## URGENT FIELD SAFETY NOTICE

<b>Single Registration Number (SRN):</b>	BE-MF-000000909
--	-----------------

**Subject:** Incorrect handling of non-square Image pixel spacing in Enterprise Imaging XERO Viewer at initial load leads to incorrect placement of reference lines.

- Enterprise Imaging XERO Viewer (UDI-DI: 05400874000710)

Figure 1: Example of placement difference due to incorrect initialization in XERO Viewer

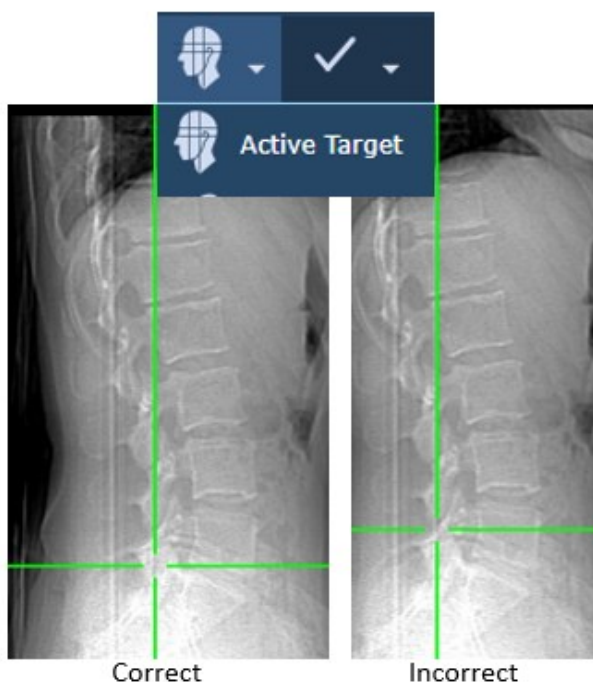
When an image has non-square pixel spacing, the reference/localizer line is incorrectly placed on the scout image in the XERO Viewer (offset from actual position). For example, when viewing a CT localizer radiograph, also known as a scanogram or scout image in the sagittal plane next to an axial series, the localizer/scout line or the active target localization tool may display the incorrect crosshair/line position on the non-coplanar/scout image with respect to the axial slice location.

This misplacement occurs only initially when viewing the anatomy in the non-coplanar image within XERO Viewer. When a user scrolls through other available scout/non-coplanar images in a series, or replaces the current image in the display area with another series and then returns to the first scout image viewed, the reference/localizer line or active target crosshair will subsequently be correctly placed.

### Example of reference line placement difference in an affected study

### Example of Active Target placement difference in an affected study

AGFA HealthCare will provide the software corrections for the affected versions. A patch is available for each of the following XERO Viewer version streams:

- Use the XERO Viewer Extended Tools component (Xtend), if enabled.
- Use the Enterprise Imaging Desktops viewer
- Scroll through other available scout/non-coplanar images in a series, or replace the current image in the display area with another series in order to correct any potentially misplaced scout line.
